**COMMITTEE OF THE WHOLE (PUBLIC MEETING) – NOVEMBER 30, 2021****COMMUNICATIONS****Distributed November 26, 2021****Item(s)**

**Re: Vaughan Committee of the Whole Meeting of November 30,  
2021  
Item No. 4 - File No. 26.7  
Promenade Centre Secondary Plan ("PCSP")  
Our Client: 1529749 Ontario Inc.  
Our Client's Lands: 7700 Bathurst Street, City of Vaughan**

**RE: Vaughan Committee of the Whole (Public Hearing)  
Item No. 4, File No. 26.7  
Promenade Centre Secondary Plan ("PCSP")  
7700 Bathurst Street**

LEA Consulting Ltd. Consulting Engineers and Planners www.LEA.ca			Project No. 22008	7700 BATHURST ST VAUGHAN ONTARIO	PROPOSED ROAD NETWORK Ultimate Condition	Drawing No. SK01
			Date AUG 10, 2021

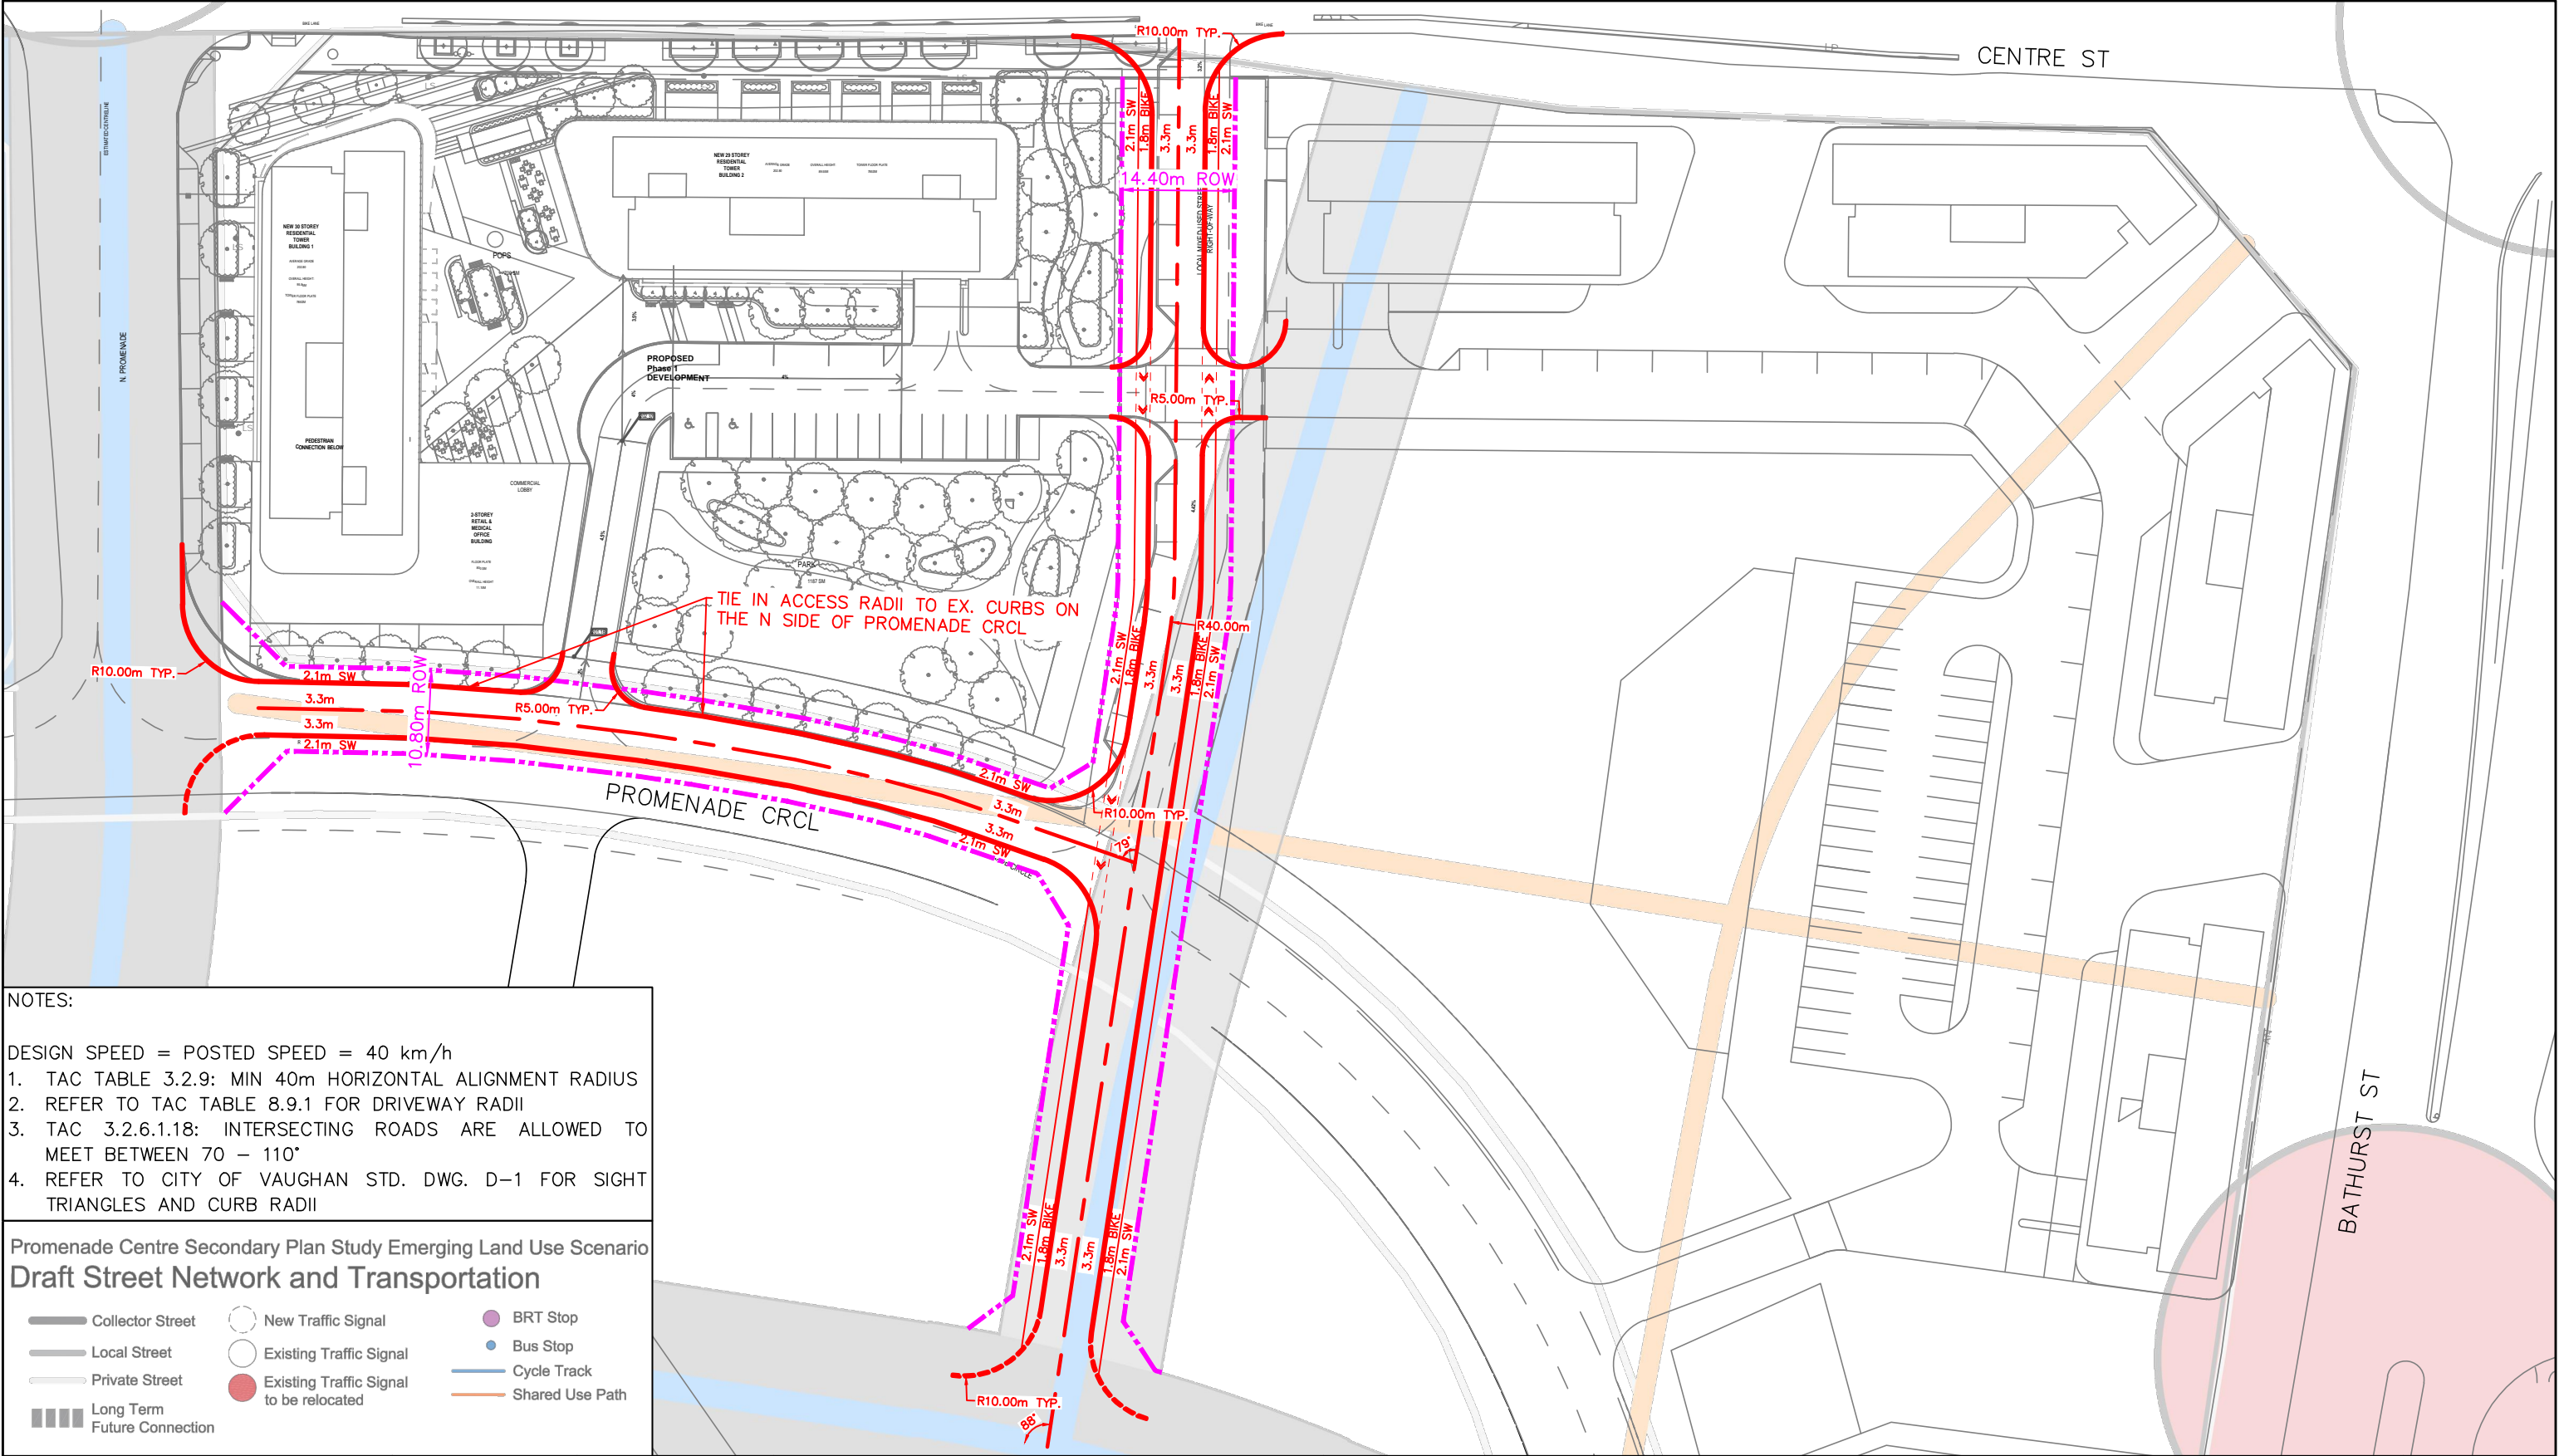
7. As part of the proposed development and Phase 1 planning application, LEA Consulting, the Owner/Applicant's Transportation Consultant, prepared plan view drawings (entitled SK01 and SK01) of the proposed interim and ultimate road networks, included as Appendix 'E' of their Transportation Impact Study, dated September 2021, in response to the proposed Secondary Plan's Multi-Modal Transportation Network. These drawings were considered and are under review by the City of Vaughan as part of the latest re-submission of the planning applications. The LEA Consulting interim and ultimate road network drawings are enclosed to this letter as Attachment 2.

## Schedule E

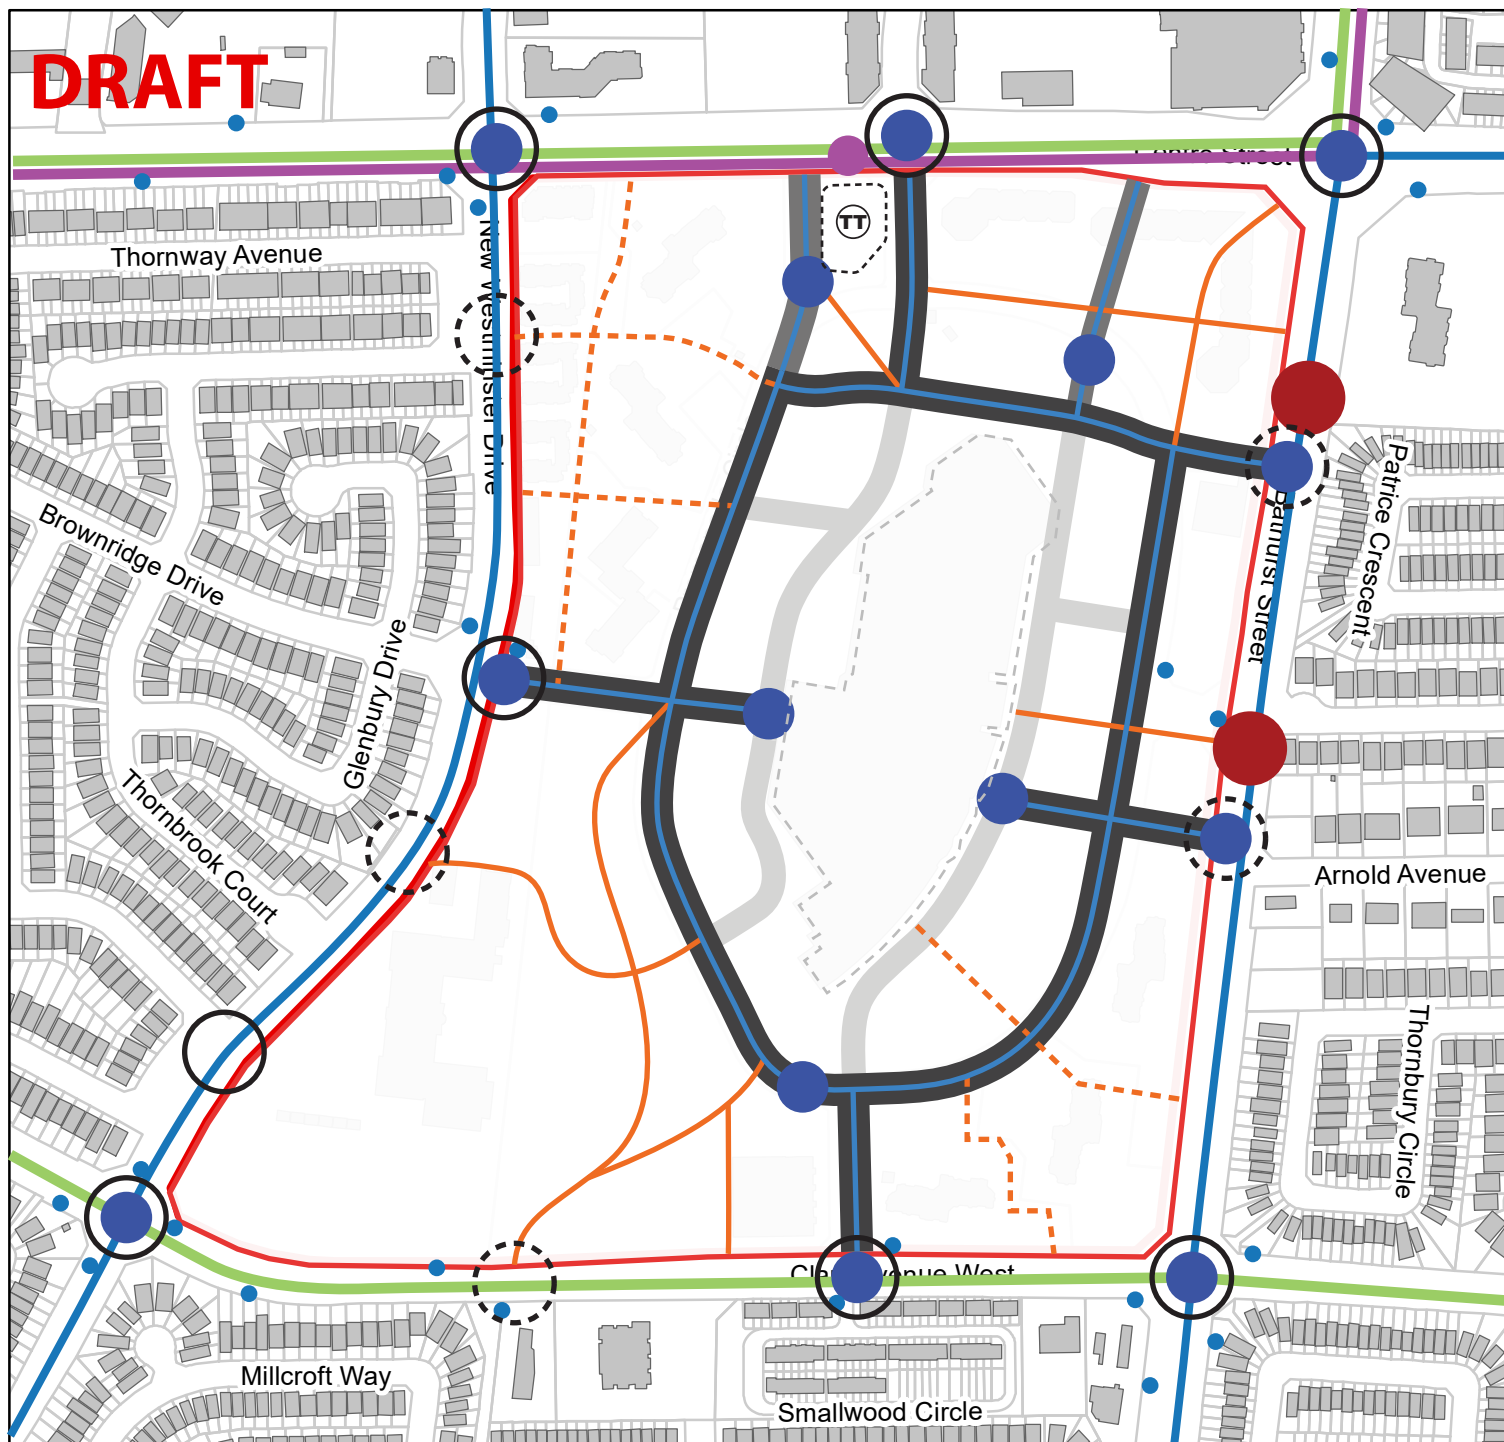
6. We support the general principles proposed on Schedule 'E' – Multi-Modal Transportation Network in the Draft PCSP; however, we request that the City consider the following proposed modifications to Schedule E and the corresponding policy framework, as outlined herein:

- a. We request that the City modify the west leg of the shared use path to be identified as private local linkage on Schedule 'E' of the Secondary Plan. We request that the east-west portion of this linkage not preclude or limit two-way vehicular access.

- b. We request confirmation that the shared use paths on the east side of the north-south road identified on Schedule 'E' of the Secondary Plan, are flexible in location and will be able to accommodate service and passenger vehicles.

- c. We request that the north-south road identified on Schedule 'E' of the Secondary Plan be revised to be private, yet provide public access to the City of Vaughan.

We have prepared a modification to Schedule 'E' to reflect the comments as set out above in 6a to 6c. The modifications to Schedule 'E' are enclosed to this letter as Attachment 1 in the Appendix.
